FINAL  
PILOT EXTRACTION AND AQUIFER RESPONSE TEST  
WORKPLAN  
MONTROSE SITE  
TORRANCE, CALIFORNIA  
DSGWRD 26 – 036

Re: Submittal of Final Workplan for Pilot Extraction and Aquifer  
Response Test, Montrose Site, Torrance, California

RESPONSE TO EPA COMMENTS ON  
DRAFT PILOT EXTRACTION AND AQUIFER RESPONSE TEST WORKPLAN  
DSGWRD 26-036  
MONTROSE CHEMICAL SITE  
LOS ANGELES COUNTY, CALIFORNIA  
DUAL SITE GROUNDWATER OPERABLE UNIT  
DATED JUNE 11, 2004

FIGURE 11

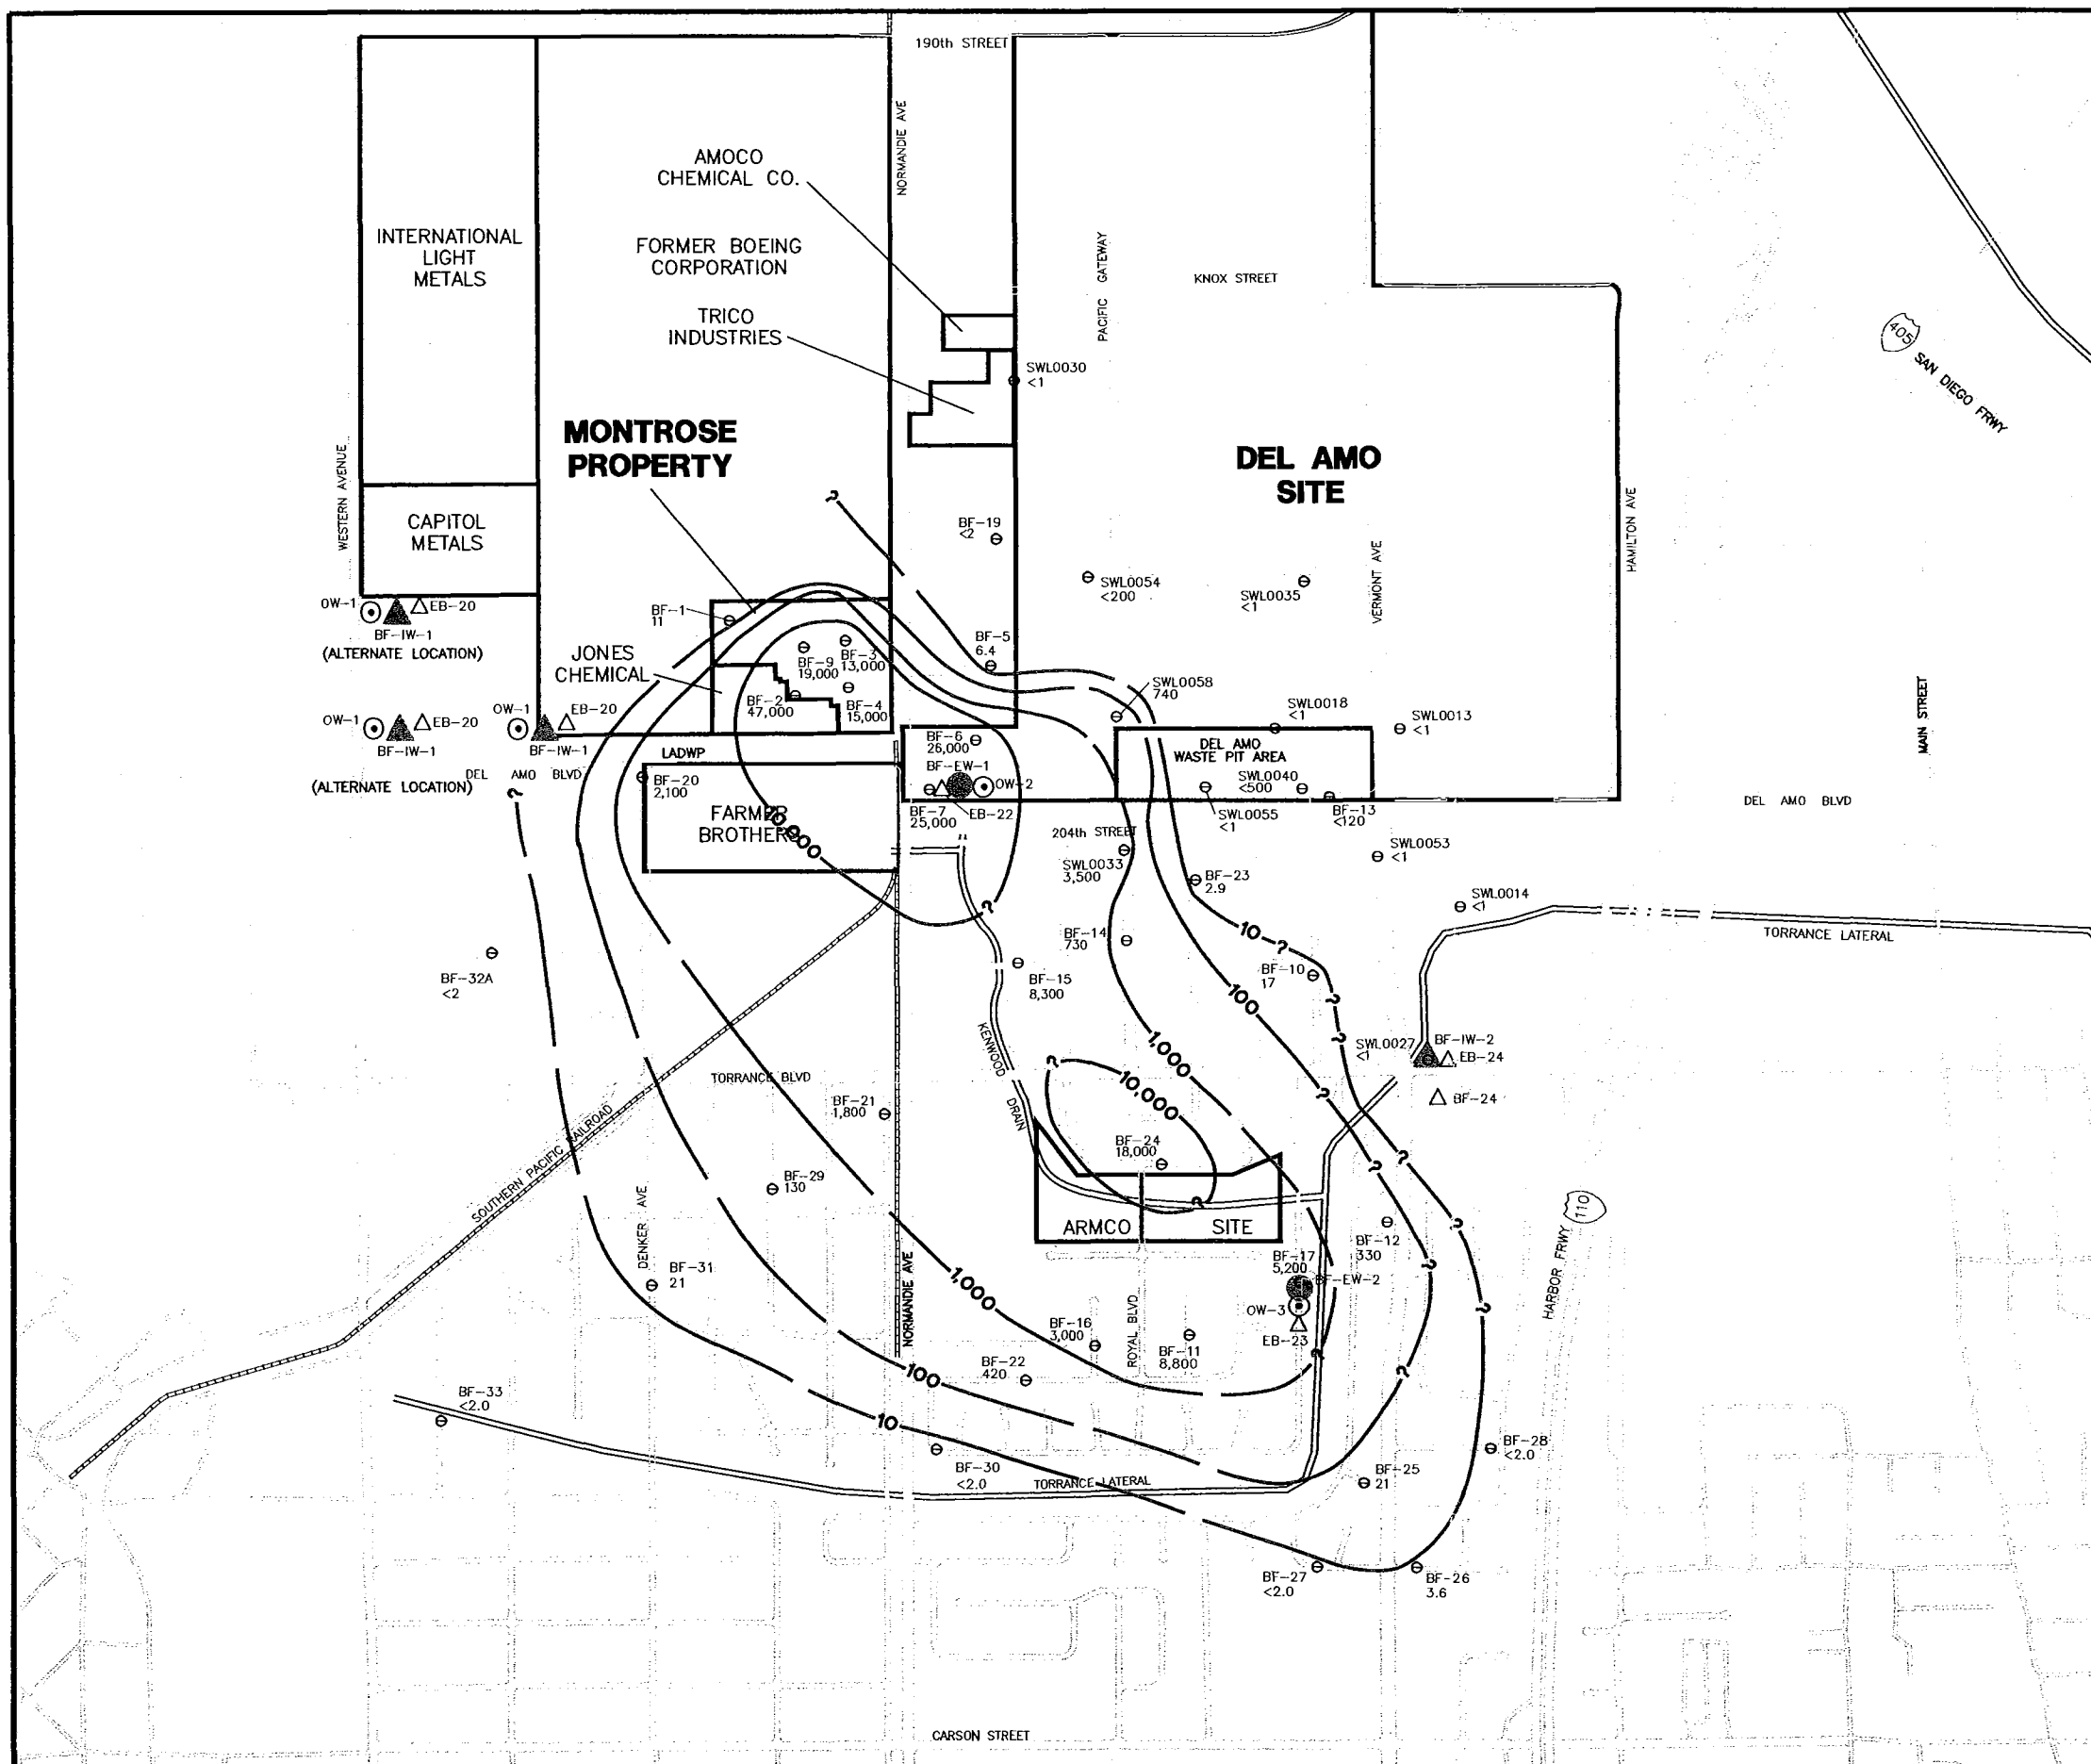
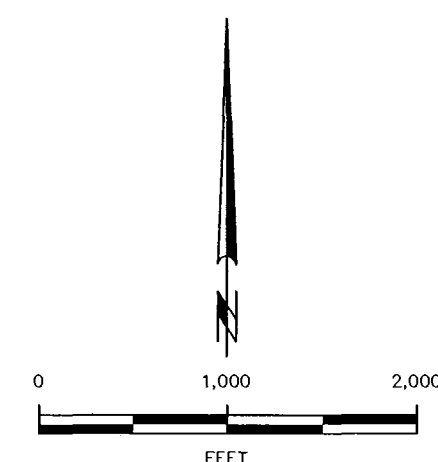
3. *The location of the proposed eastern injection well (BF-IW-2) in the Bellflower Sand is not appropriate because it is adjacent to well SWL0040, which has 100,000 ppb of benzene. As was discussed at the July 1, 2004 modeling meeting, the alternate location for this well could be adjacent to well SWL0027. We have held conversations with Montrose regarding the optimum location of the moved extraction well; we request that the modified Workplan be reflective of those conversations.*

**RESPONSE:** Bellflower sand extraction well BF-EW-2 has been relocated to the toe of the chlorobenzene plume as discussed in the July 1, 2004 meeting. Section 3.1.1 and Figure 11 of the Workplan have been revised accordingly.

**RESPONSE:** Bellflower sand injection well BF-IW-2 has been relocated adjacent to SWL0027. Section 3.2.1 and Figure 11 of the Workplan have been revised accordingly.
